INITIAL FIRE SAFETY INSPECTION REPORT

N.K. Sweaters Ltd.

Date: 10 March 2024

Fire Safety Inspection Report

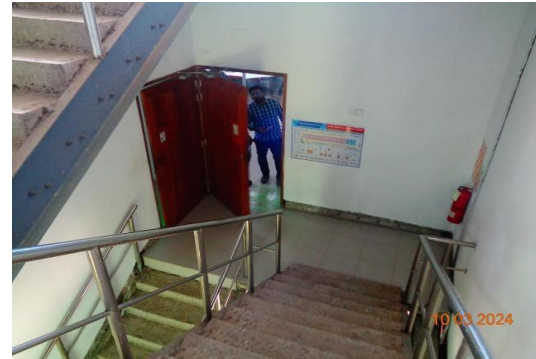
F-6	Fire Rated Construction	Areas used for in-process storage of combustible materials are open to the surrounding occupancy. Location: Shed-01 & Shed-03.	Provide defined storage areas and limit the storage arrangement as follows:- 1. General Condition: Maximum height of 2.4m and maximum area of 23m². Separate areas of unenclosed combustible storage by a minimum clear distance of 3m. 2. If sprinkler protected: maximum height of 3.66m and maximum area of 93m². Separate areas of unenclosed combustible storage by a minimum clear distance of 3m. or 3. Enclose the storage area from the surrounding occupancy with a minimum 1 hour construction.	Within 3 Months
-----	-------------------------	---	---	-----------------

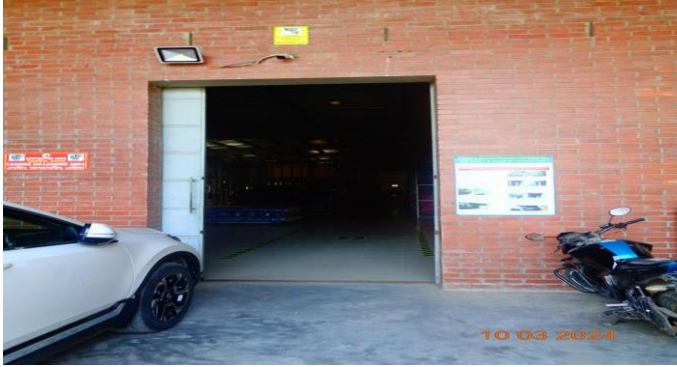
F-7	Fire-Rated Construction	Dining area is not separated from Generator, compressor and fire pump room.	Seal all penetrations and openings to the interior of the Generator, Compressor and Fire pump room along the discharge path to provide a minimum 3-hr fire separation.	Within 3 months
-----	-------------------------	---	--	-----------------
